NEW MEXICO
ENVIRONMENT DEPARTMENT

Hazardous Waste Bureau

**RE: REPLACEMENT PAGES, QUARTERLY PRE-REMEDY MONITORING AND SITE INVESTIGATION REPORT FOR JANUARY-MARCH 2011, BULK FUELS FACILITY SPILL, SOLID WASTE MANAGEMENT UNITS ST-106 AND SS-111, MAY 2011
KIRTLAND AIR FORCE BASE, EPA ID# NM9570024423
HWB-KAFB-11-008**

Figure 1. From Replacement Pages, Figure 5-4, Groundwater Level Contours March 2011. Note water-level elevations of 4857.11 ft for KABB-10614 and 4856.00 ft for KAFB-10619. Compare these water-level elevations with those shown in Figure 2 and listed in Table 1.

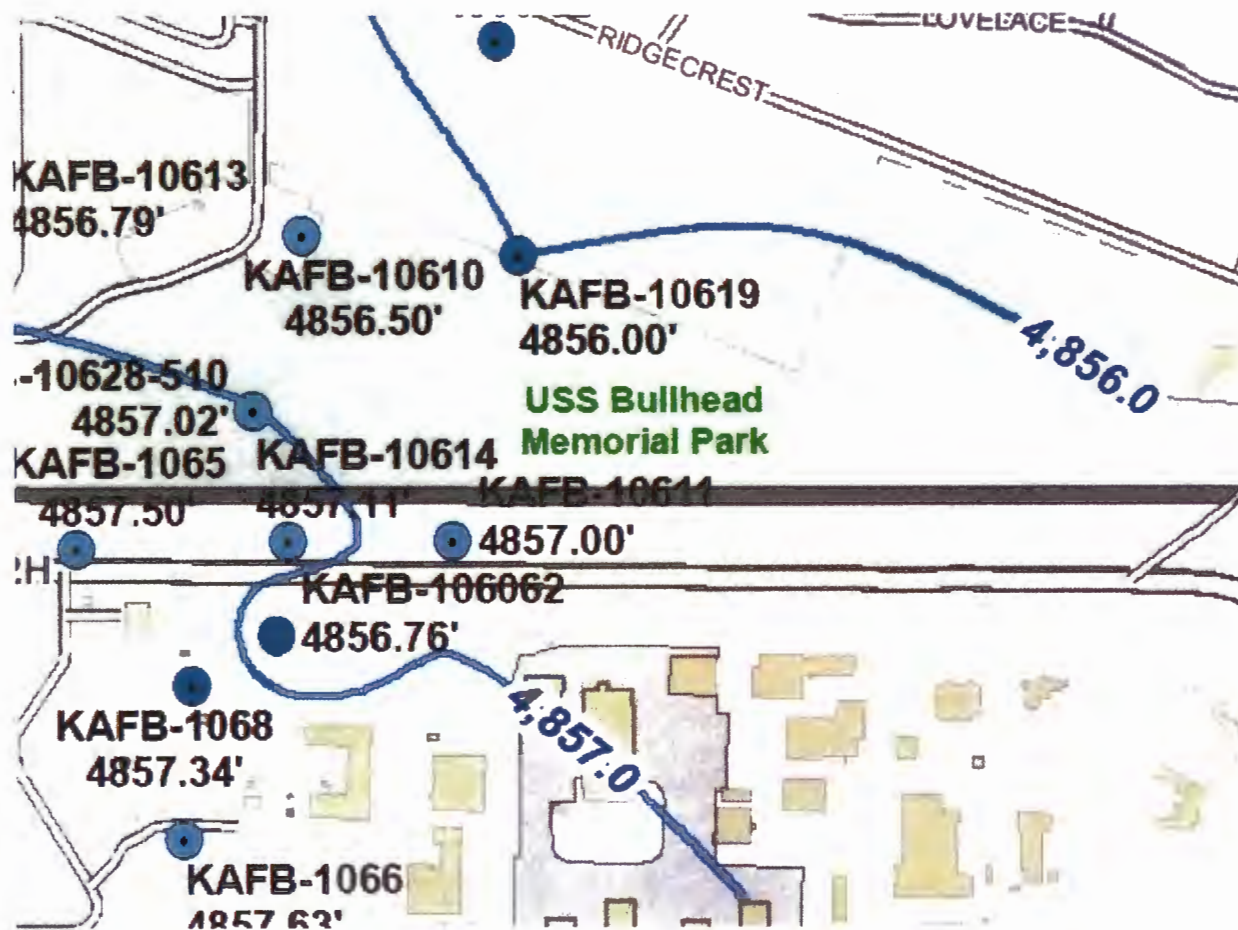
1. The U. S. Air Force (Permittee) submitted revisions of Figures 5-2 through 5-4 (Groundwater Level Contours) as part of the Replacement Pages without providing an explanation for the revisions. Table 5-2 (Historical Groundwater Level and Liquid Measurement Data) appears to be the same in both the original report and the Replacement Pages (other than a pagination change). However, not all data posted on the figures match their corresponding data in the table. For example, in March 2011 the water-level elevation for monitoring well KAFB-10614 is shown as 4857.11 ft in Replacement Pages Figure 5-4, as 4856.91 ft in Figure 5-4 of the original report, and is listed as 4856.62 ft in Table 5-2 (the cited figures and table are reproduced here in part as

Figures 1 and 2 and Table 1 of this letter). In fact, there are numerous other examples of such inconsistencies between the figures and the table, indicating that the water-level map shown in Figure 5-4 (of the original report and the Replacement Pages) and/or the data in Table 5-2 may be replete with errors, and thus, are unreliable. The Permittee must correct the figures or the table, or both, as necessary and resubmit the corrected information to the NMED. Also, Figures 5-2 and 5-3 must also be corrected, as they have problems similar to those described above for Figure 5-4. Furthermore, any changes in the figures or table would probably necessitate changes to Figure 5-5 (Groundwater Gradient March 2011), also resubmitted in the Replacement Pages. If so, Figure 5.5 must also be corrected and must also be submitted to the NMED.

3. NMED notes a water-level contour constructed with a bend at nearly a right angle, specifically the 4856.0-ft contour near KAFB-10619 on Figure 5-4 of the Replacement Pages (reproduced here in part as Figure 1 of this letter). Typically, such sharp angles would not be expected as a component of the contours that model the water table of an unconfined aquifer in an unconsolidated basin-fill environment. NMED also notes the odd, contorted 4857.0-ft contour that nearly completely surrounds KAFB-106062 (see Figure 1 of this letter) and questions whether this odd geometry is related to survey error or other error. The Permittee must justify such unusual components of the model of the water table, or revise the model to be consistent with that expected for natural conditions.

Also note water-level contour constructed at nearly a right angle, specifically the 4856.0-ft contour placed near KAFB-10619, and odd contorted 4857.0-ft contour line constructed nearly completely around KAFB-106062.

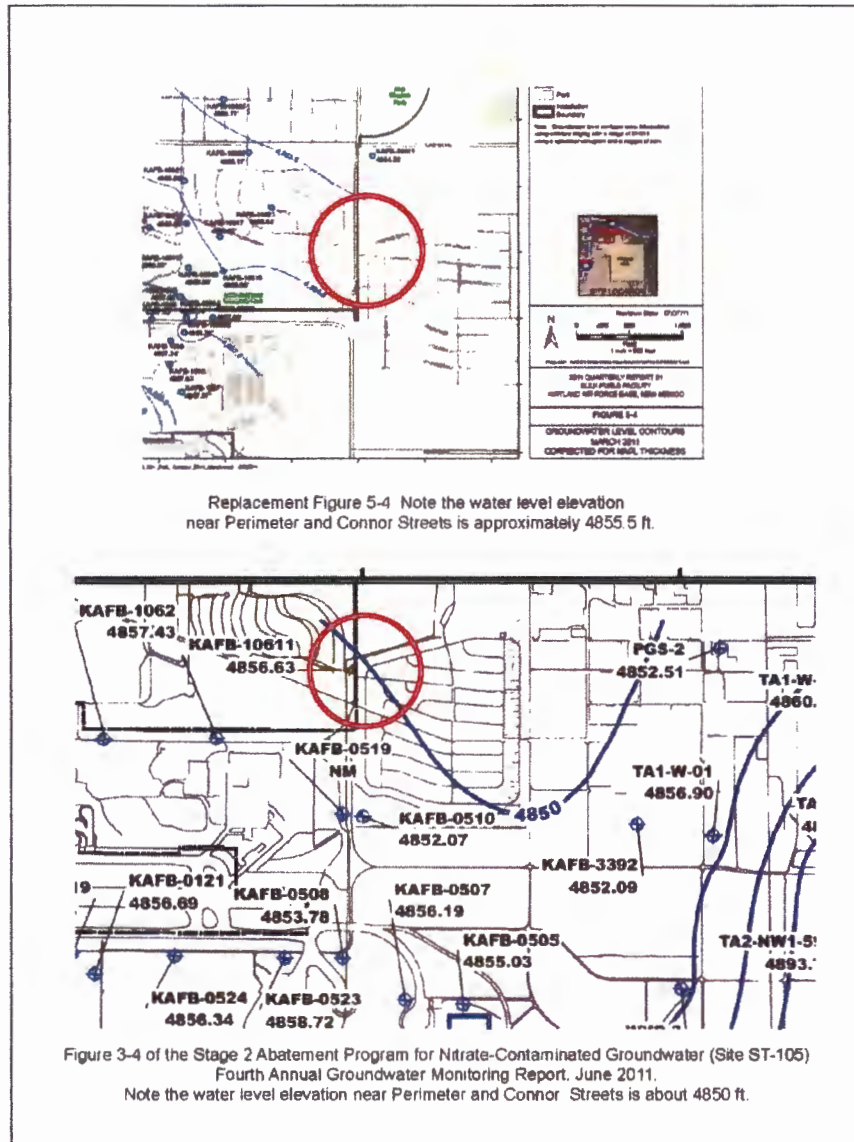
2. As discussed with the Permittees and their contractor at a technical meeting held on July 12, 2011, the Permittees submitted a water-level map in the document *Stage 2 Abatement Program for Nitrate Contaminated Groundwater (Site ST-105) Fourth Annual Groundwater Monitoring Report, June 2011* (this map is reproduced here in part as the lower map in Figure 3 of this letter). On this map, the water-level elevation near the intersection of Perimeter and Connor Streets is about 5 ft lower compared with that shown on Figures 5-2 through 5-4 of the Replacement Pages (and the same figures in the original report) for a similar time period. Taking into consideration the water-level elevation for KAFB-0510 (as presented in the nitrate report), the geometry of the water table on the east side of Bulk Fuels Facility could be considerably different from that presented in the Replacement Pages and other reports for the Bulk Fuels Facility Spill, and, as a consequence, the groundwater flow direction and gradient for this area could be markedly different from that previously determined. The Permittee must correct the figures for the Bulk Fuels Facility Spill quarterly report as necessary and submit the corrected figures to the NMED. The Permittee must also correct any figures that are erroneous in the aforementioned nitrate report and must submit the corrected figures to the NMED Ground Water Quality Bureau, with a copy to the NMED Hazardous Waste Bureau.

Figure 4. Comparison of Colog and Jet West Long Normal (deep) Induction Log at KAFB-106

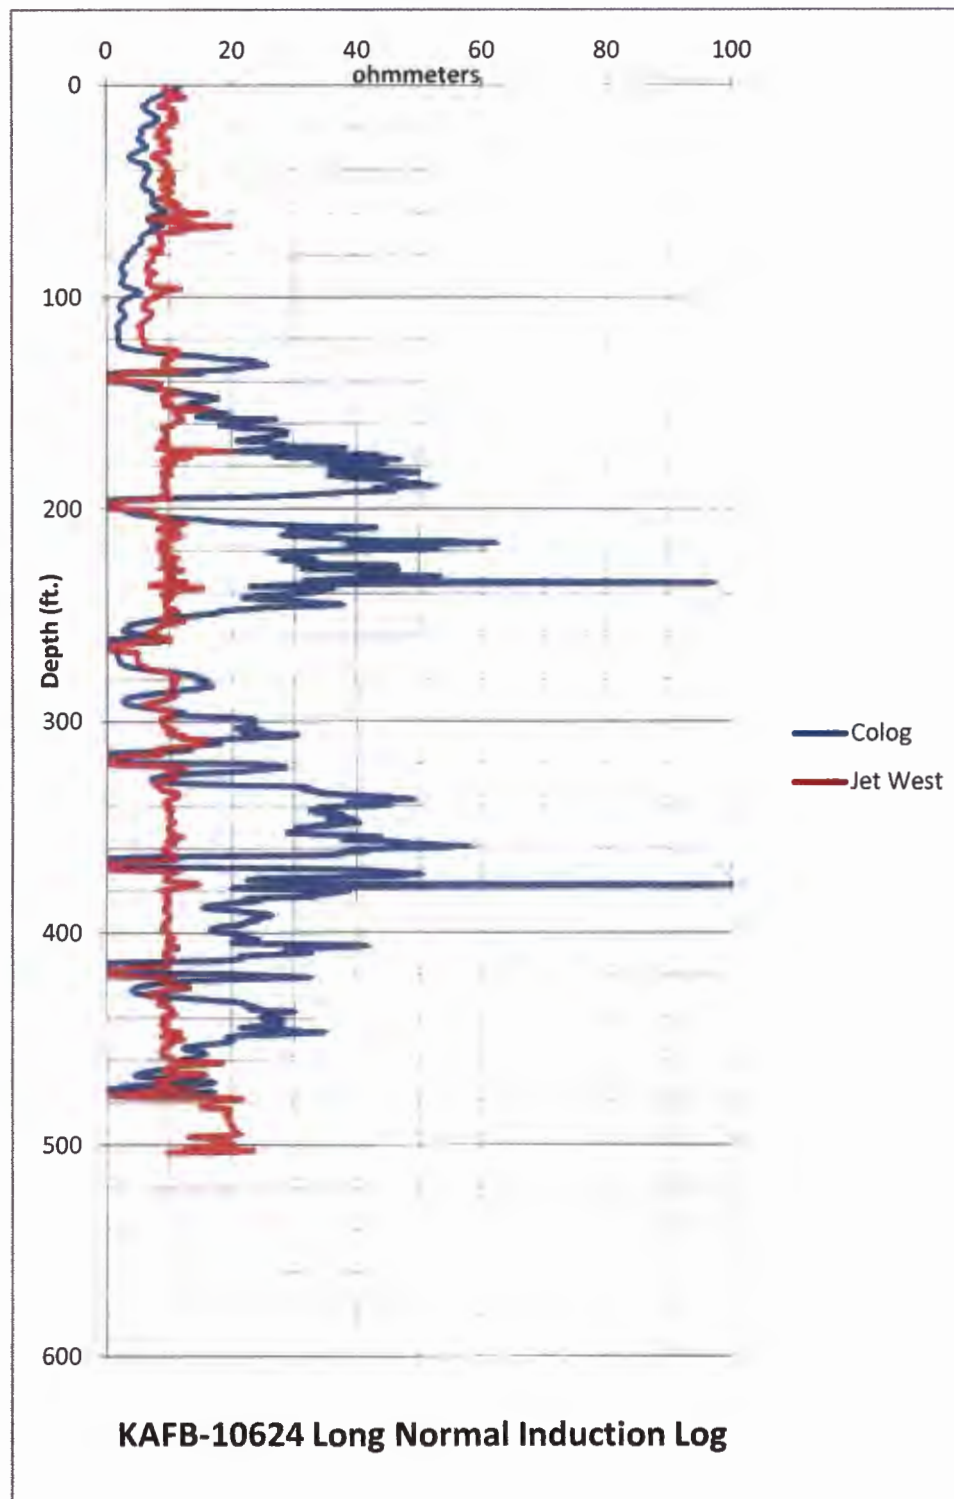
Example 1: The geology of one well, KAFB-10624 was logged by both Colog and Jet West; the long normal (deep) induction logs for KAFB-10624 are shown in Figure 4 of this letter. For about half of the well logs, the resistivity values in the Colog data are about 2 to 4 times higher in magnitude compared to the Jet West data. In other areas of the well logs, the Colog resistivity values are less than the Jet West resistivity values. Because the well environment did not change, these data show that at least one set, and possibly both sets, of the logging instruments that generated the logs were not properly calibrated to a known standard (ohmmeters).

Figure 5. Comparison of Gamma logs generated by Colog and Jet West at KAFB-10624. In each case the gamma tool was run with another tool, either the neutron or the induction tool, as noted in the legend.

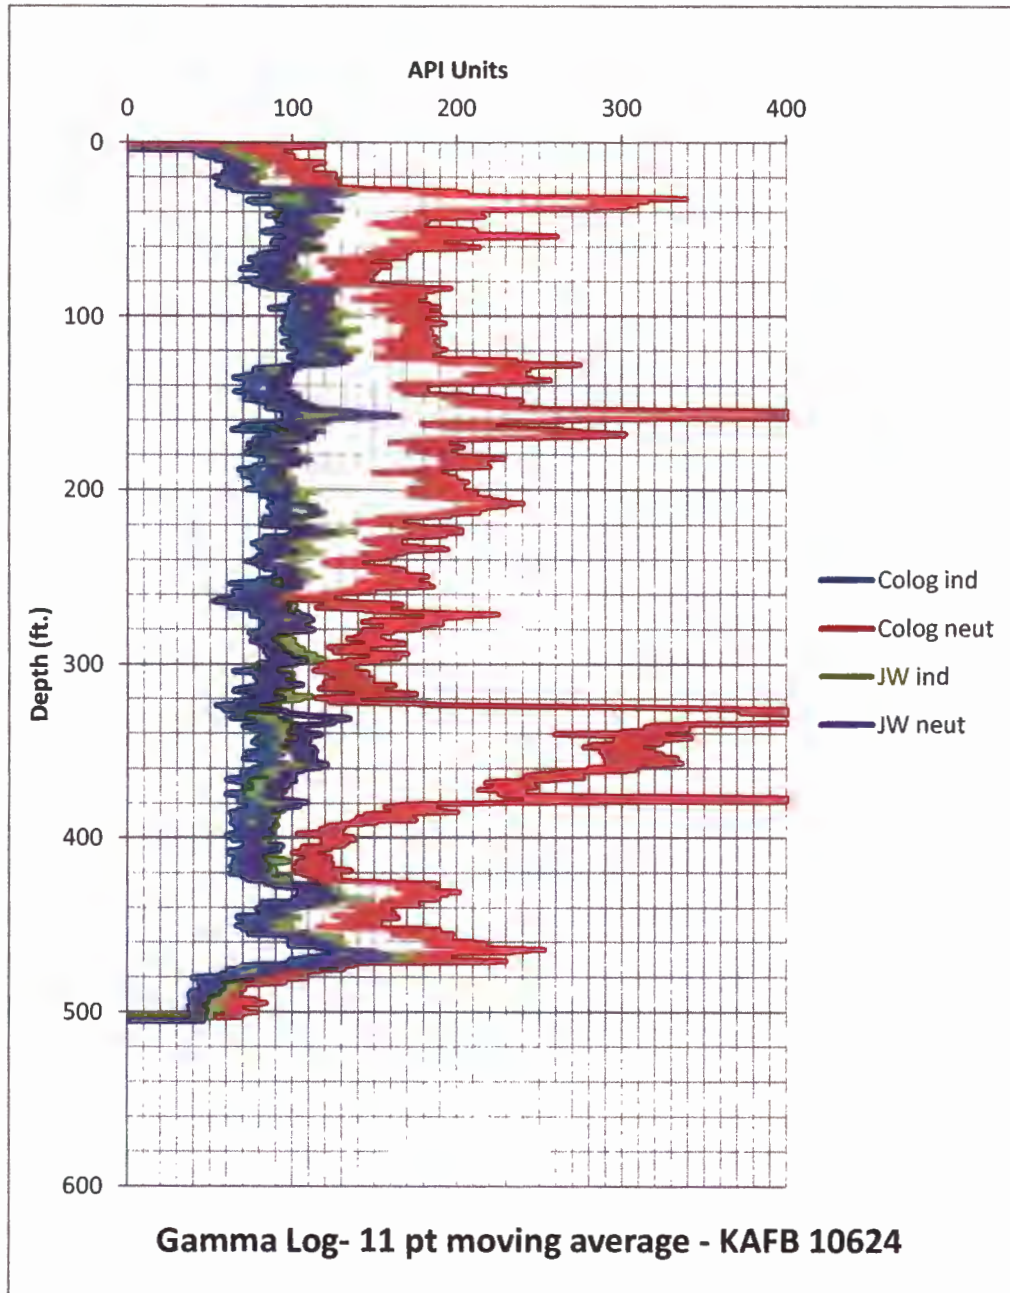
Example 2: Both logging contractors produced two gamma logs each for KAFB-10624; one each associated with the induction tool and one each associated with the neutron tool (see Figure 5). While 3 of the 4 logs match up reasonably well, the gamma log generated by Colog on the neutron tool is considerably different in magnitude (API units) than the other three logs suggesting that one or more of the logging tools was not properly calibrated.

Figure 6. Comparison of Long Normal (deep) Induction Log between three wells in one cluster, with one of the wells logged by Colog (10627) and the other two wells logged by Jet West (106044 and 106045).

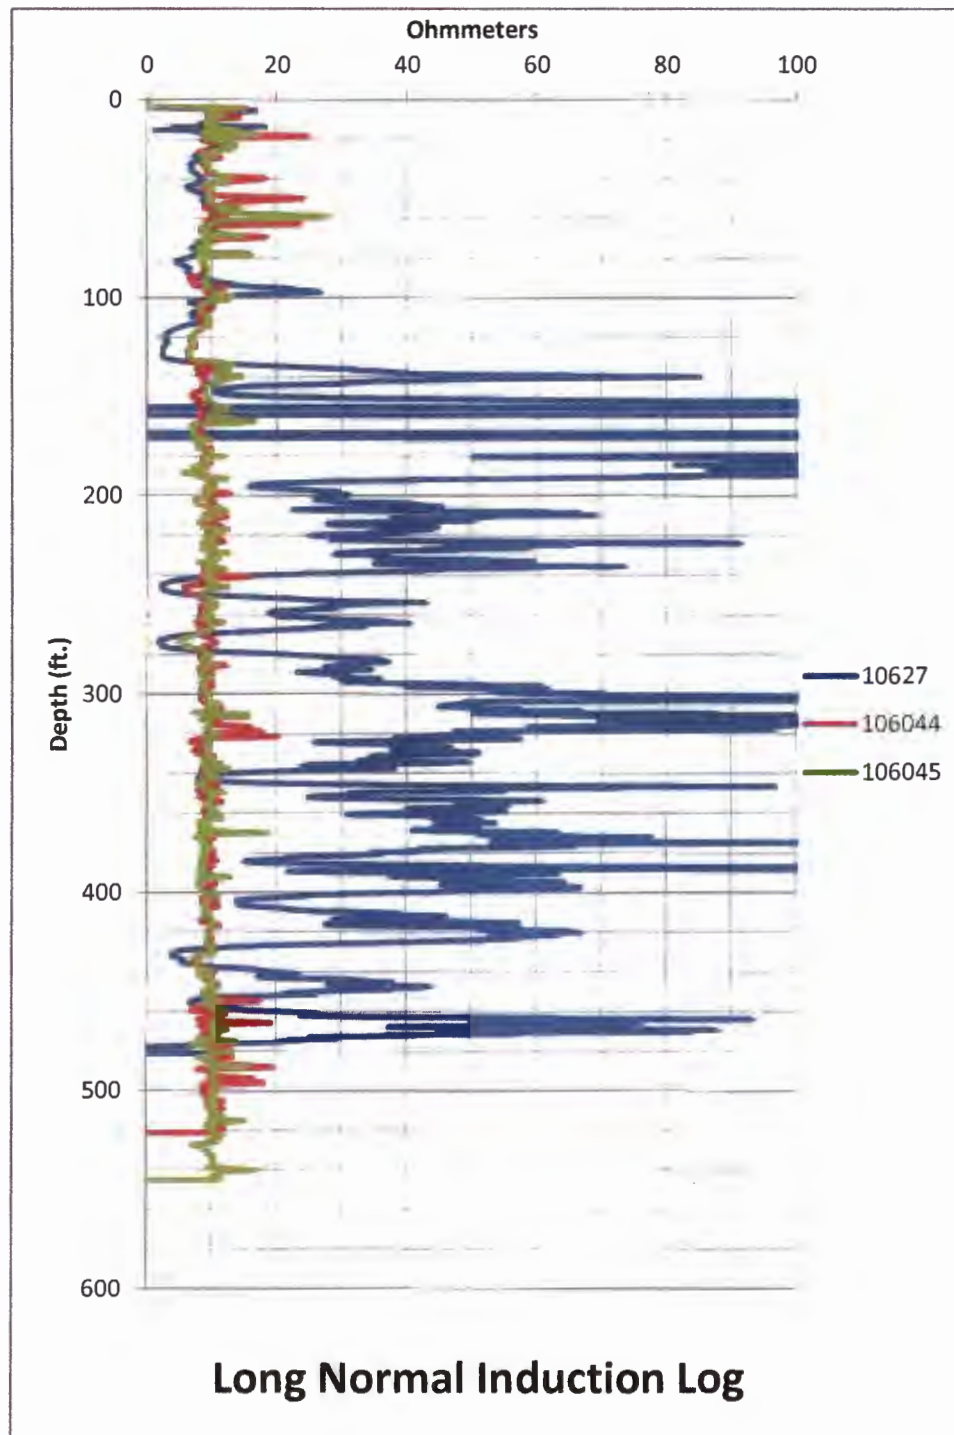
Example 3: Figure 6 (and Figure 5) illustrates the importance of having calibrated logs to evaluate the lateral characteristics of a given lithologic unit. Figure 6 shows the logs for the well cluster including wells KAFB-10627, KAFB-106044, and KAFB-106045. The log for well KAFB-10627 produced by Colog exhibits very different resistivity values compared to the logs for KAFB-106044 and KAFB-106045 that were generated by Jet West -- even though the wells are only a few tens of feet apart. These discrepancies are not likely caused by changes in lithology, but instead, are caused by a lack of proper calibration of one or more of the logging tools. Furthermore, Figure 6 (and Figure 5) suggest both the Colog and Jet West logs were generated using instruments that were not properly calibrated.

Figure 7. Comparison of neutron logs generated by Colog and Jet West at KAFB-10624.

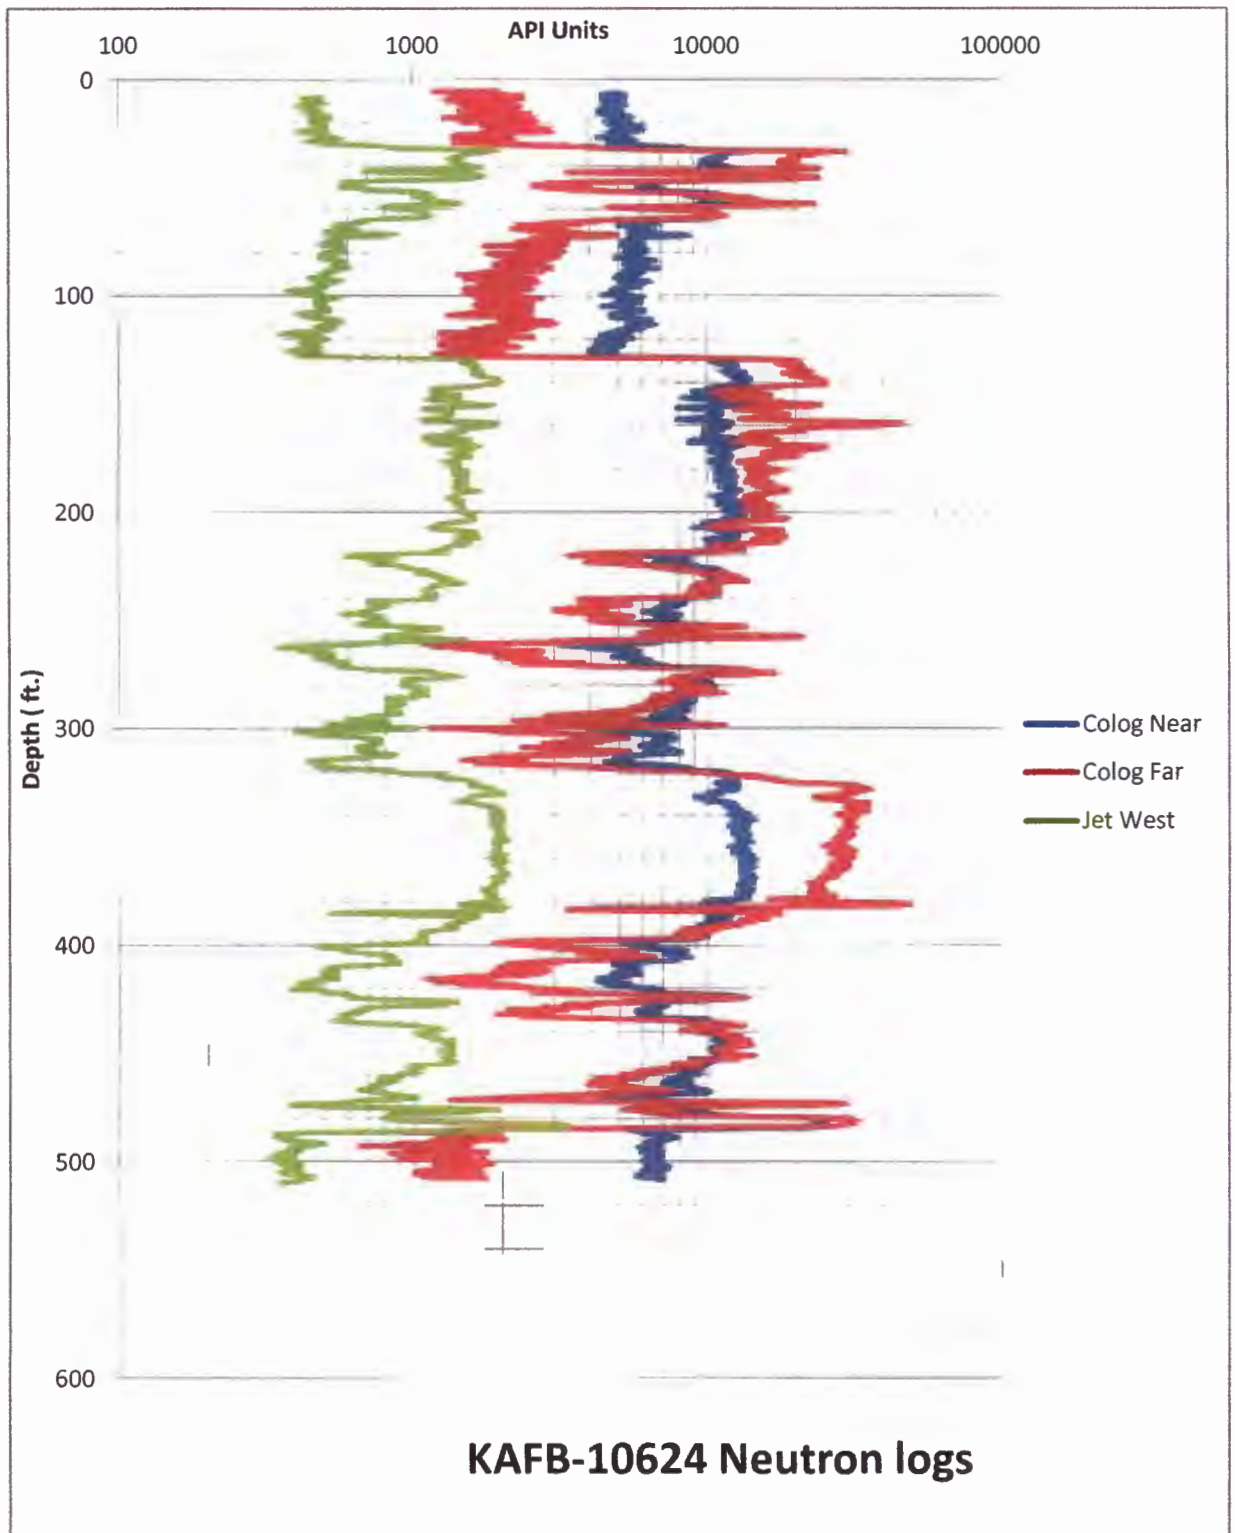
Both contractors generated neutron logs from the logging of well KAFB-10624. Colog produced both near and far neutron logs and Jet West produced a single neutron log for the well. There is a difference of an order of magnitude between the two sets of neutron logs produced by the two contractors (see Figure 7 of this letter).

The NMED also questions the reliability of estimating porosity values from neutron logs exhibiting such markedly different API counts as discussed in Example 4 above. NMED has no confidence in the accuracy of either the Colog or Jet West neutron logs based on the information presented in Figure 7 and the issues related to calibration of the other log types discussed in this letter. For this reason, the Permittee must respond in writing to this comment by stating how it will obtain porosity values from the logs, that it will repeat the neutron logging with properly calibrated tools, or propose another method to measure porosity for the Bulk Fuels Facility Spill project. Porosity data are needed both for saturated conditions throughout the project site and also for the vadose zone in the vicinity of the former fuel offloading rack and perhaps for other source areas that may be present at the Bulk Fuels Facility.
